TILLAMOOK COUNTY PLANNING COMMISSION

Date: February 6, 2025
To: Tillamook County Planning Commission
From: Melissa Jenck, CFM, Senior Planner
Subject: February 13, 2025, Planning Commission Hearing

Included in this packet is a copy of the staff report and related materials regarding requests #851-24-000483-PLNG/ 851-24-000483-PLNG-01/ 851-24-000483-PLNG-02.

Applicant has proposed a 5-unit multifamily dwelling to be used as a condominium. The applicant has requested an exception to the 50-foot riparian setback to 20-feet, and an exception to the 10-foot front yard setback to 4.4-feet. The application has not been heard before the Planning Commission, outside a continuance originally granted at the December 12, 2024 hearing. The request was originally continued to the January 9, 2025 hearing date, which was then cancelled at the Applicants request. The applications were re-noticed January 14, 2025 for this February 13, 2025 hearing date.

SP - 2.0
 Scale: 1" = 10'-0"

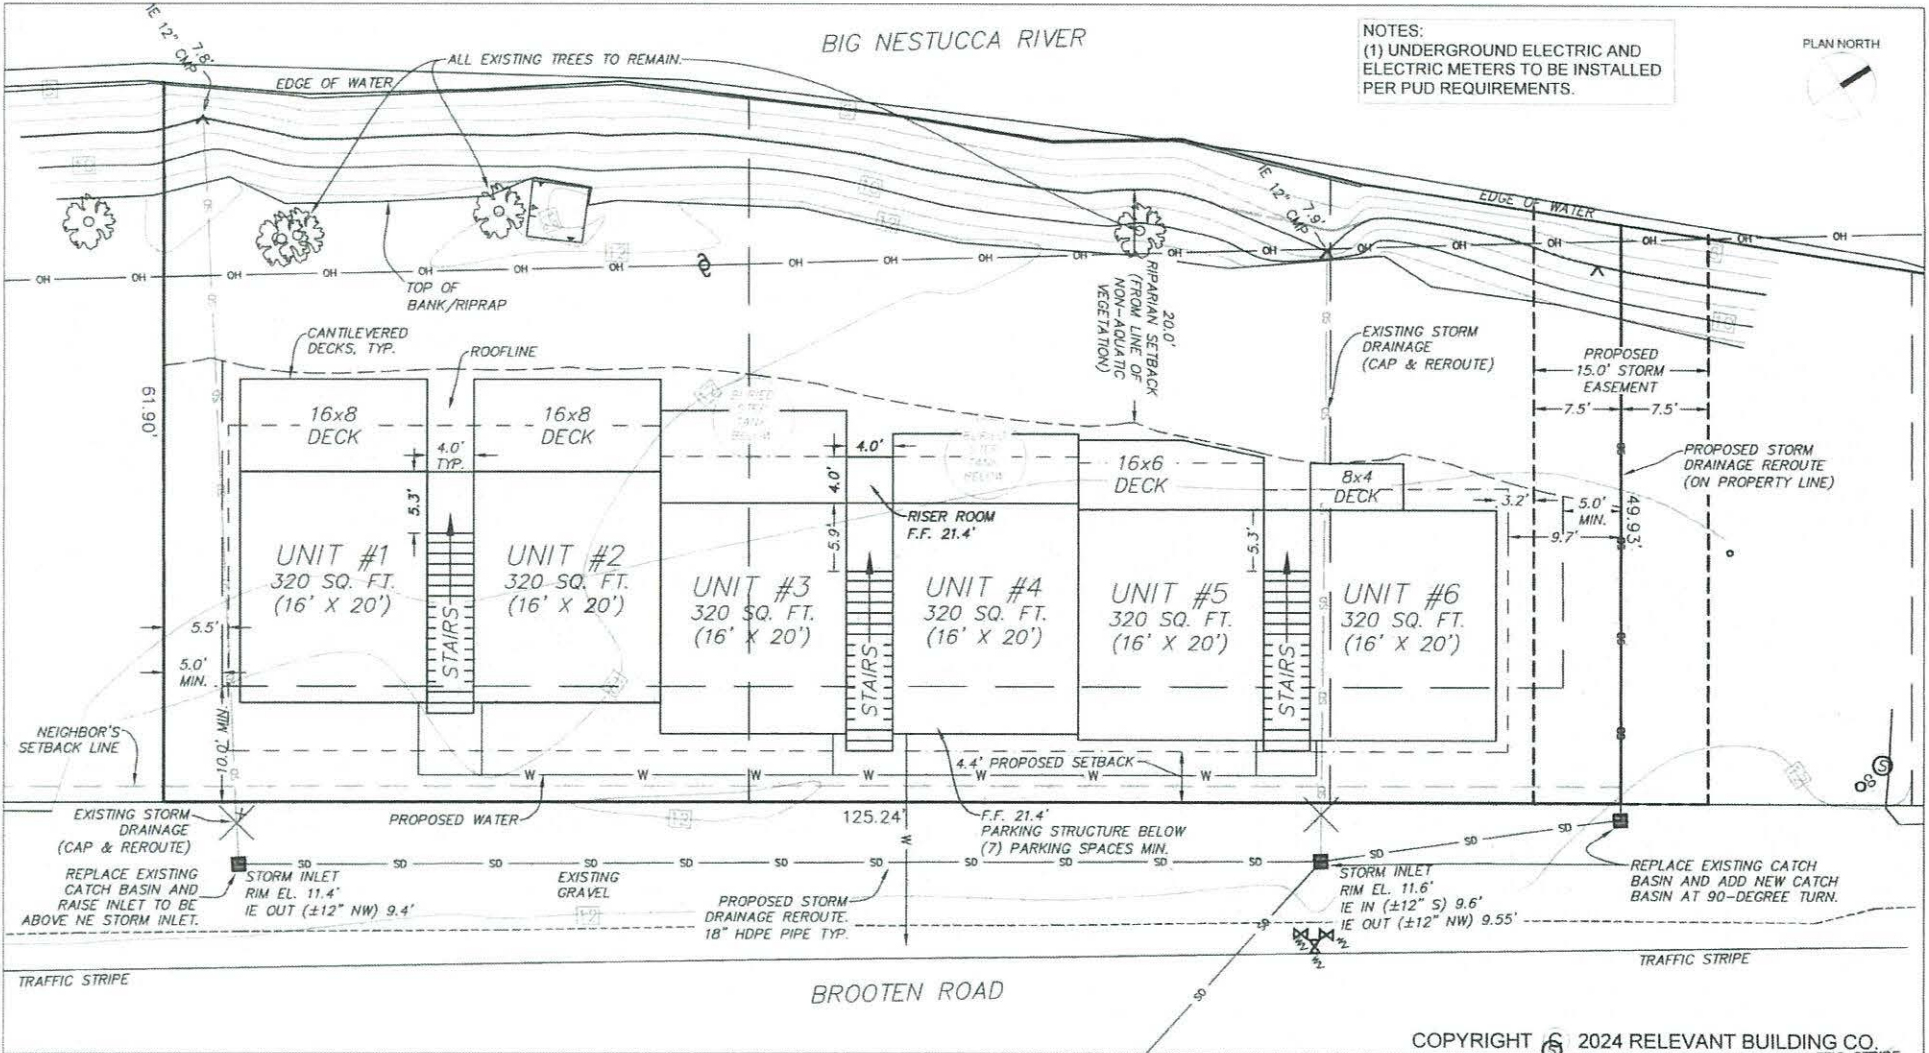
- Update Sheet SP 2.0 stormwater alignment to match alignment on Sheet SP 1.0
- The property owner/developer will be responsible for complete installation of the drain system, the County will supply standards and details for stormwater system(catch basin, frame/grate, pipe).

- The turning movement diagrams provided on Sheet SP 2.0 do not appear to meet standards for the minimum design vehicle in AASHTO Manual (Passenger Car (P)). Please resubmit with proper radius to confirm vehicles can safely back up without entering travel lane
